**From:** yiping@mcyengineering.com <yiping@mcyengineering.com>  
**Sent:** Monday, May 15, 2023 8:49 AM  
**To:** Madani, Mo <Mo.Madani@myfloridalicense.com>  
**Cc:** 'ives' <ives@mcyengineering.com>; 'Samir Sabagh' <ssabagh@energiasolarsa.com>  
**Subject:** Comments to FL#15709

FLORIDA PRODUCT APPROVAL #15709

**SERIES GW9994G IMPACT RESISTANT, STRAIGHT, OUTSIDE & INSIDE CORNER SEAMLESS, GLAZED WINDOW SYSTEM, 7/8" TRIPLE GLAZED**

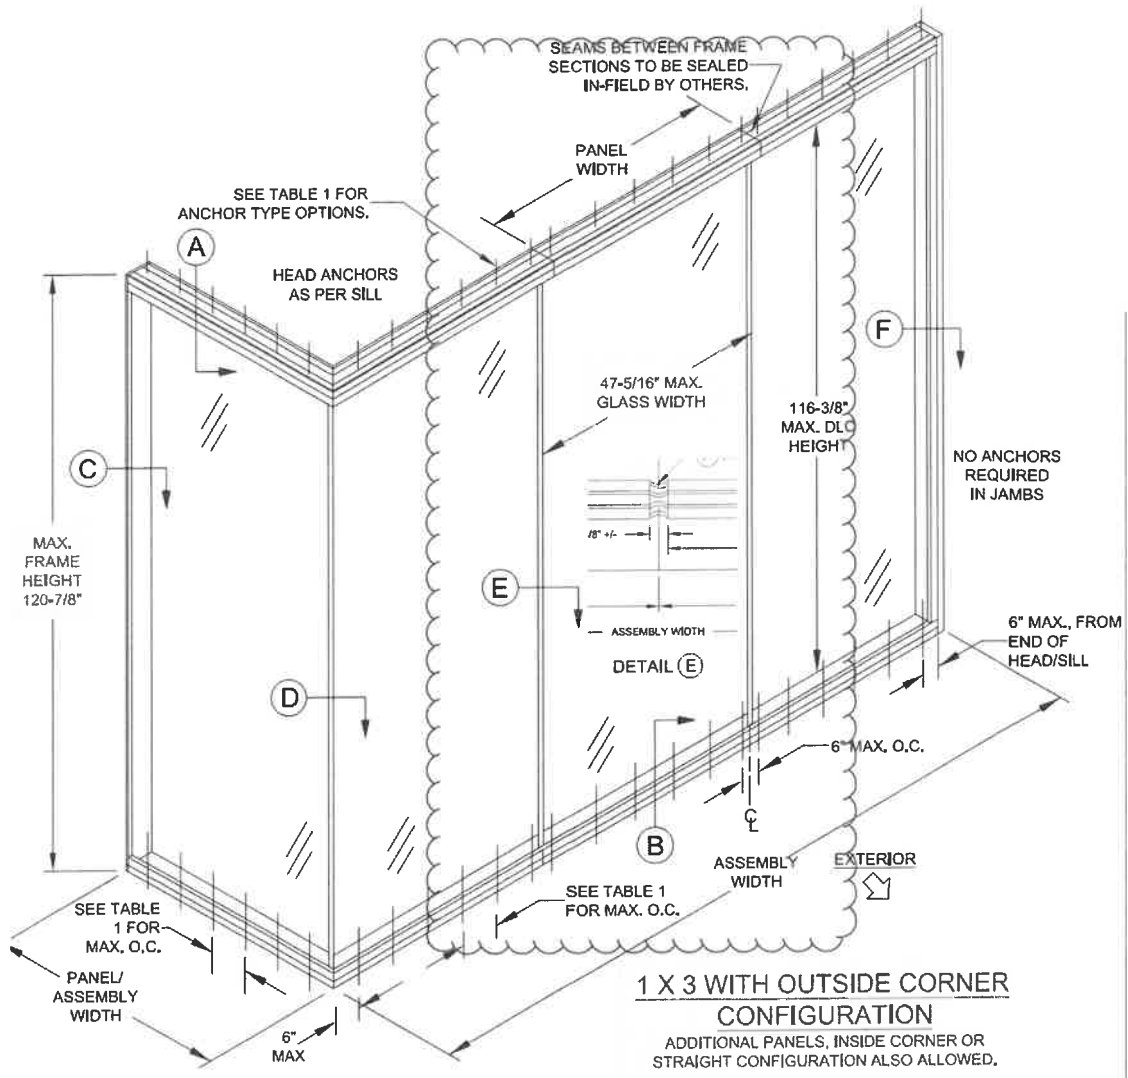
- 2) The window wall system in HVHZ not only should pass TAS 201, 202 & 203 but also the glass should also be in compliance with ASTM E1300.
- 3) In current Florida approval FL 15709 the center glass panel, in RED Cloud shown in elevation below, are supported by top and bottom only. On each side the glass, the glass edges are not supported since there is no mullion at each side. See detail E:

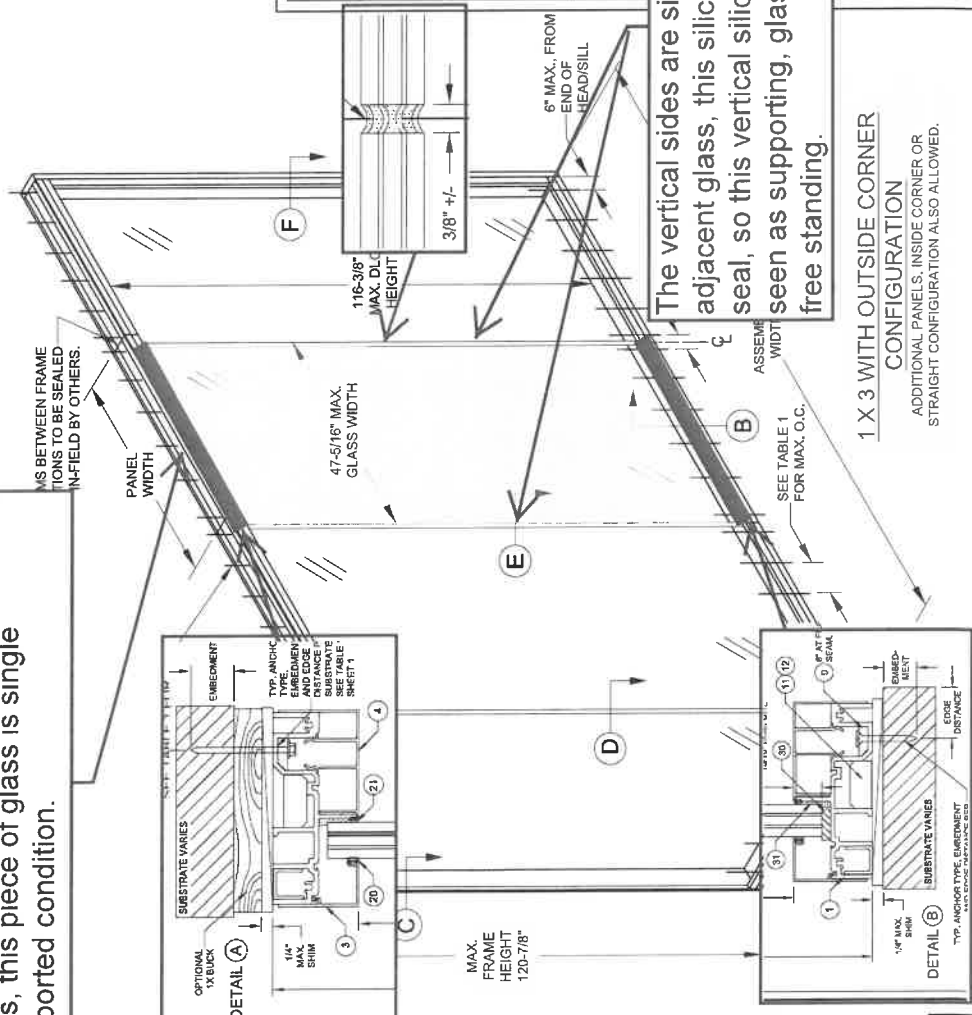
Top and bottom channels are the supporting for the yellow highlight piece of glass, this piece of glass is single supported condition.

The vertical sides are silicone between adjacent glass, this silicone is used for seal, so this vertical silicone can not be seen as supporting, glass vertical sides are free standing.
